ADDENDUM

Project Name:	UNK University Village Student Housing
Project Number:	15097
Owner:	University of Nebraska at Kearney
Addendum Number:	01, Revision 01
Date:	April 21, 2016
By:	Matt Neaderhiser, Holland Basham Architects
To:	Project Bidders

This Addendum to the project bidding documents and attached reference drawings dated April 21, 2016, issued to inform bidders of revisions to the bidding documents.

1 SECOND FLOOR PLAN - EAST WING
A1.02B
0' 2' 4' 8' 16'

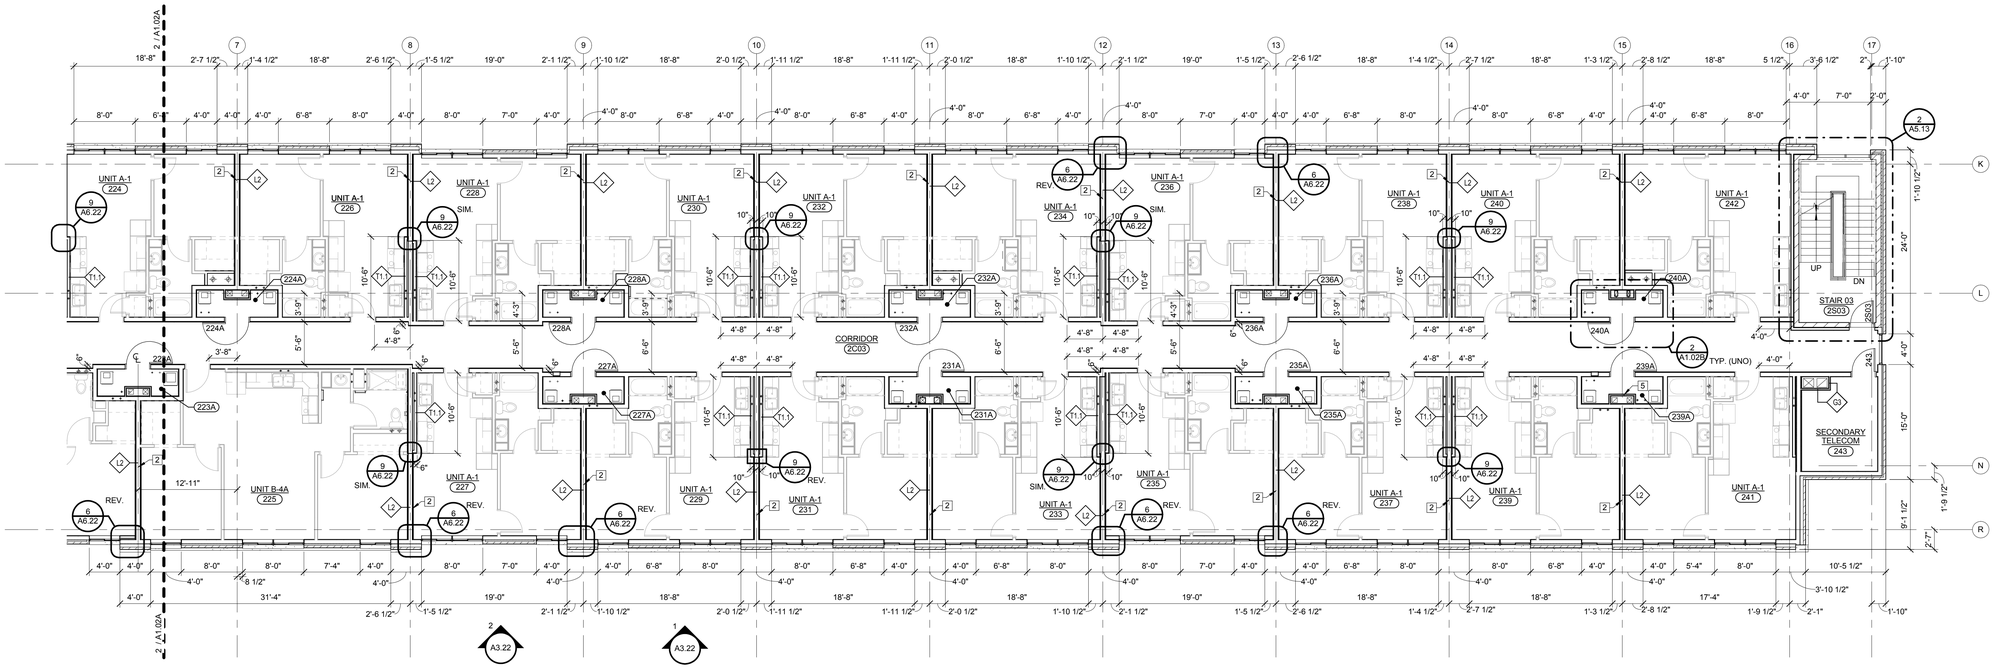
SHEET A1.02B – SECOND FLOOR PLAN – EAST WING
3. This sheet is REVISED and REISSUED with this revision.
4. Update elevation callouts.

SHEET: A1.03A

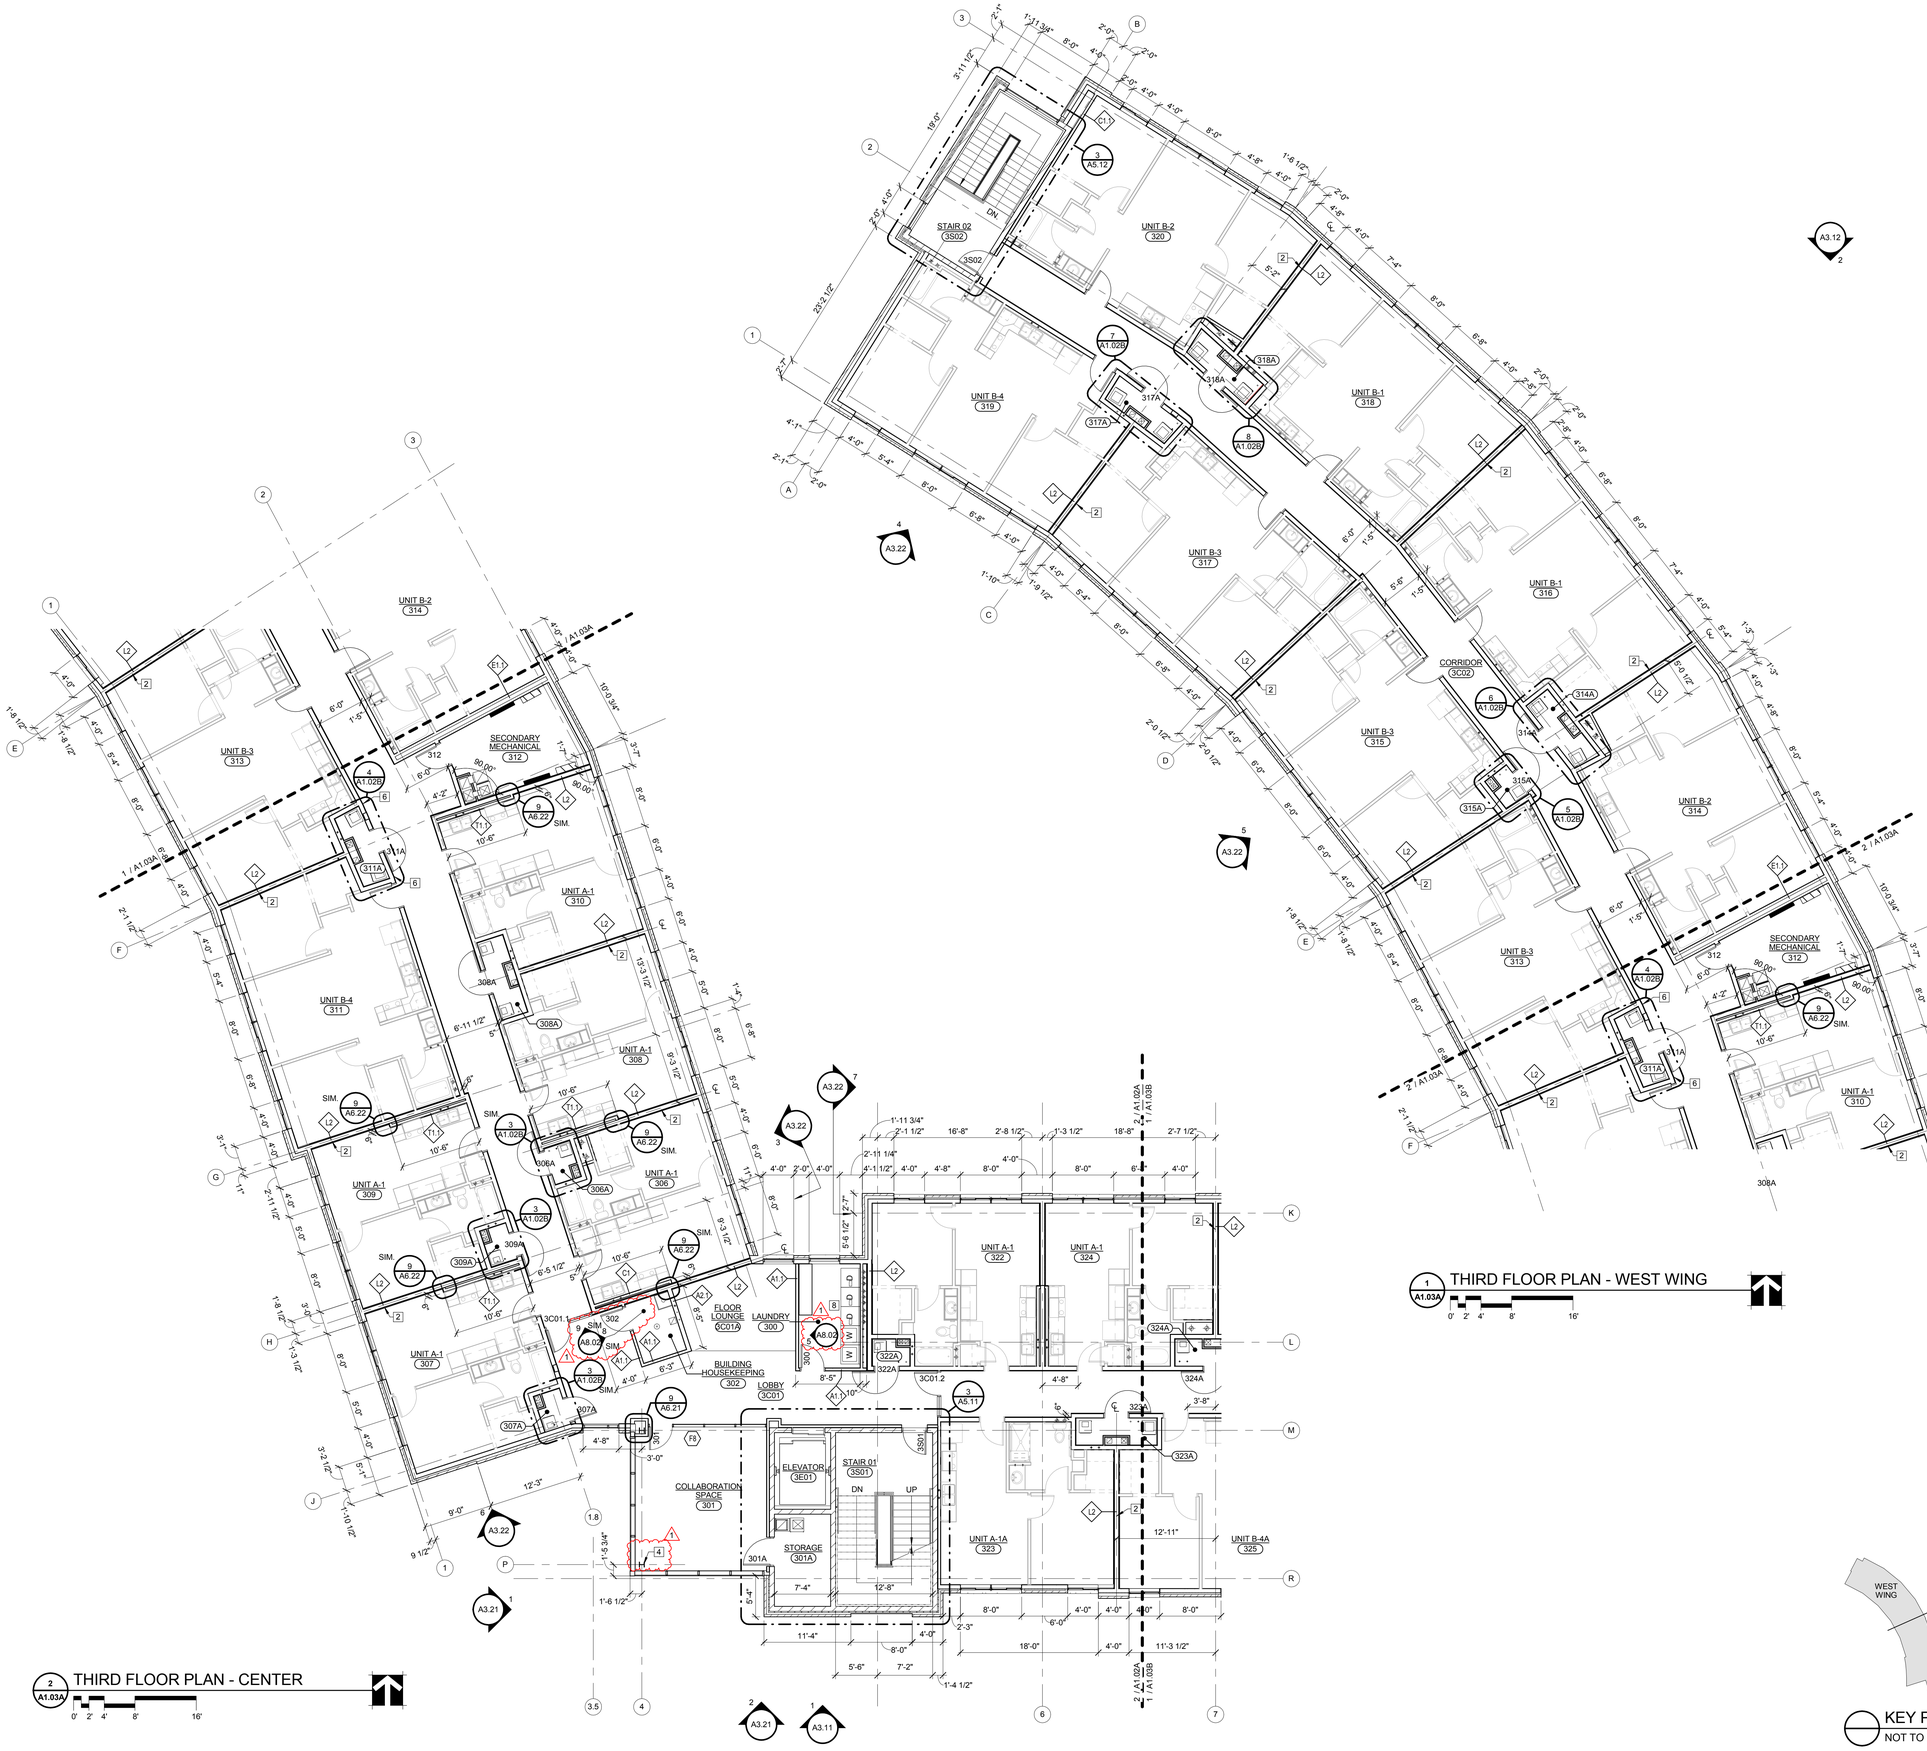
SHEET A1.03A – THIRD FLOOR PLAN – WEST WING & CENTER
1. This sheet is REVISED and REISSUED with this revision.
2. Add elevation tag to Laundry 300.

1 A1.31B FIRST FLOOR FINISH PLAN - EAST WING

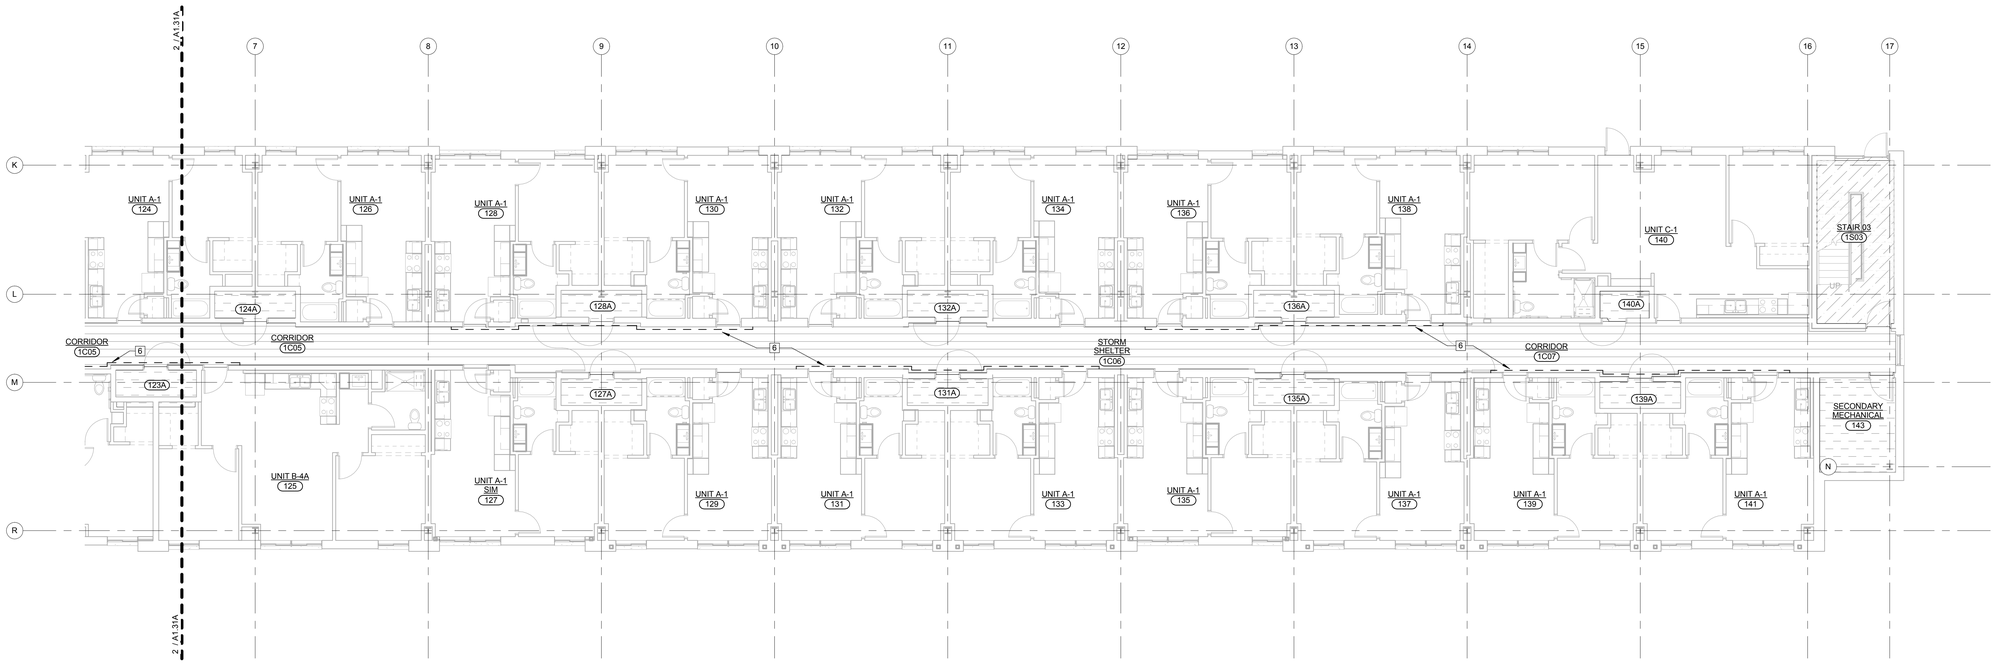
SHEET A1.31B – FIRST FLOOR FINISH PLAN – EAST WING & ROOM FINISH SCHEDULE
1. This sheet is REVISED and REISSUED with this revision.
2. Revise Material Key to indicate Sealed Concrete (PC-1).
    a. There will not be polished concrete within the project scope.
3. Remove FRP from Custodial Storage 112A.

1 A3.11 SOUTH ELEVATION

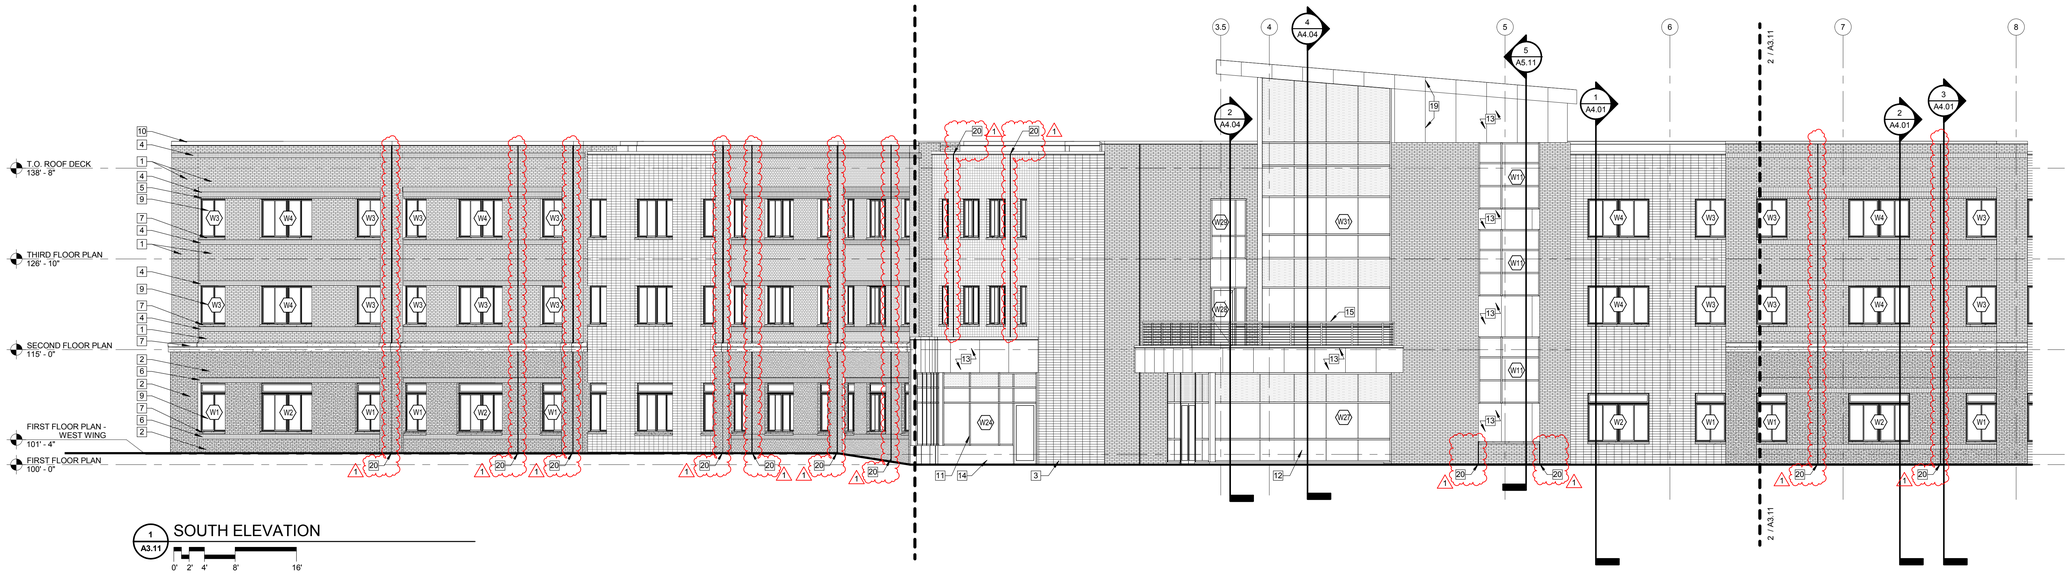
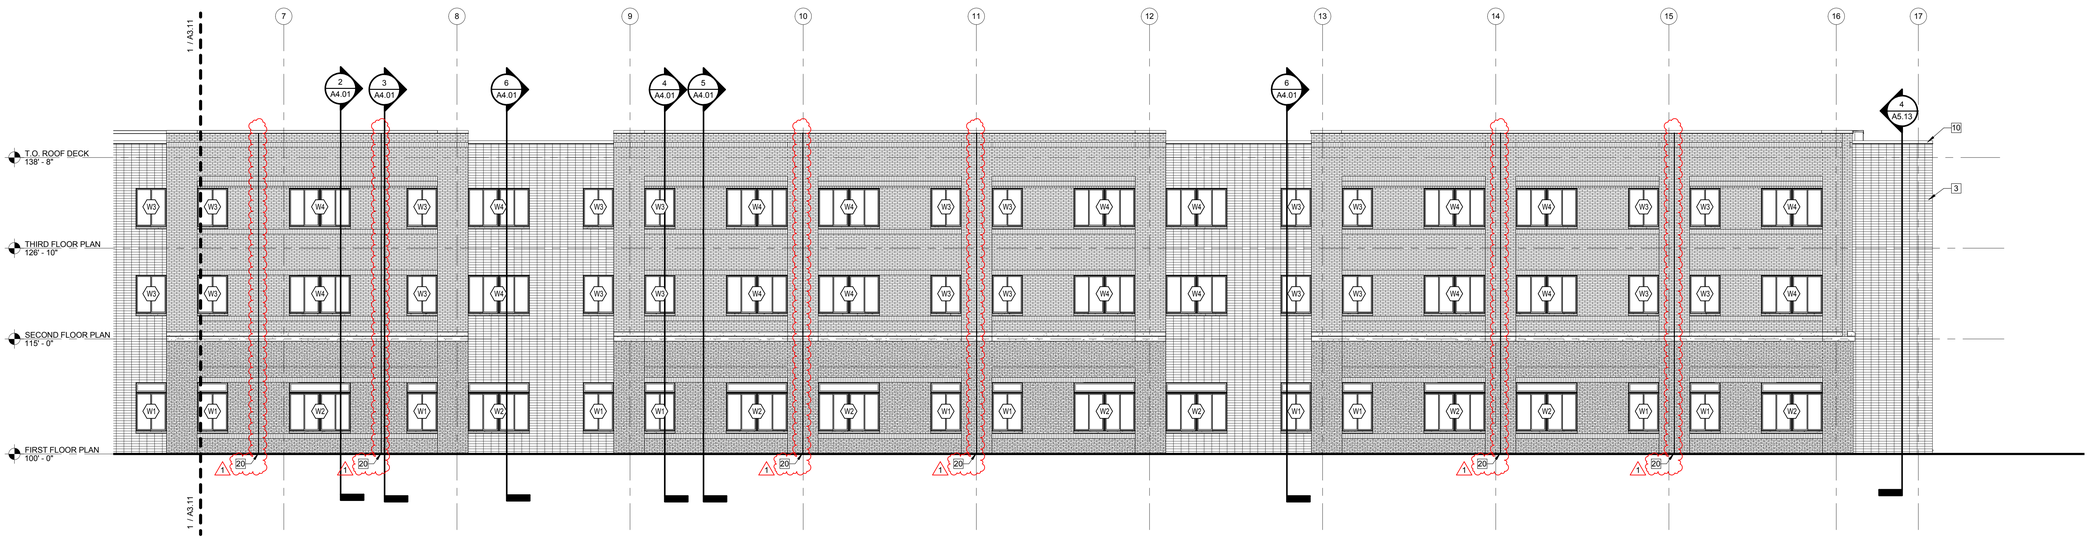
SHEET A3.11 – BUILDING ELEVATIONS
1. This sheet is REVISED and REISSUED with this revision.
2. Added control joints in the masonry.

1 / A3.12 NORTH ELEVATION

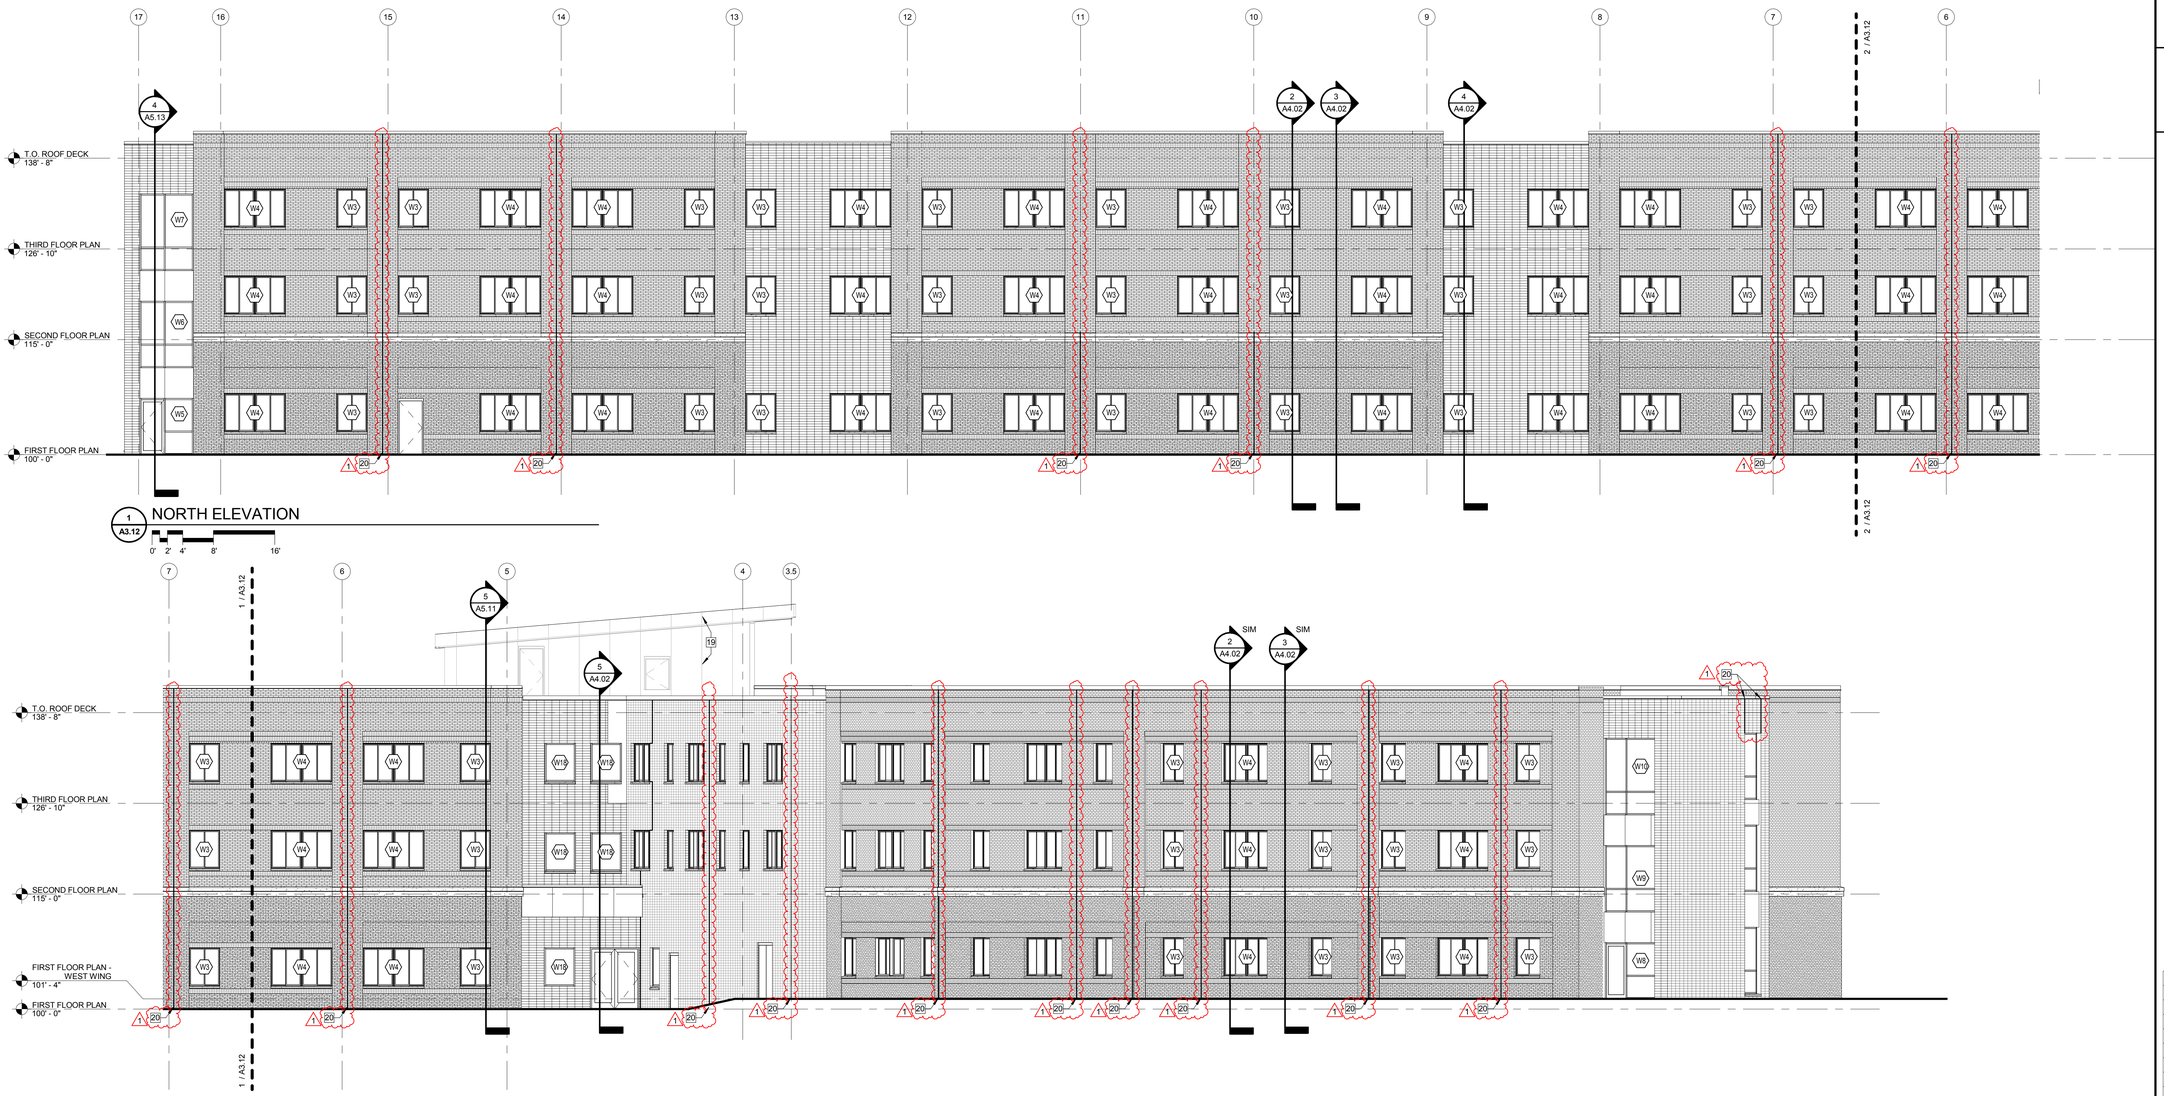
SHEET A3.12 – BUILDING ELEVATIONS
1. This sheet is REVISED and REISSUED with this revision.
2. Added control joints in the masonry.
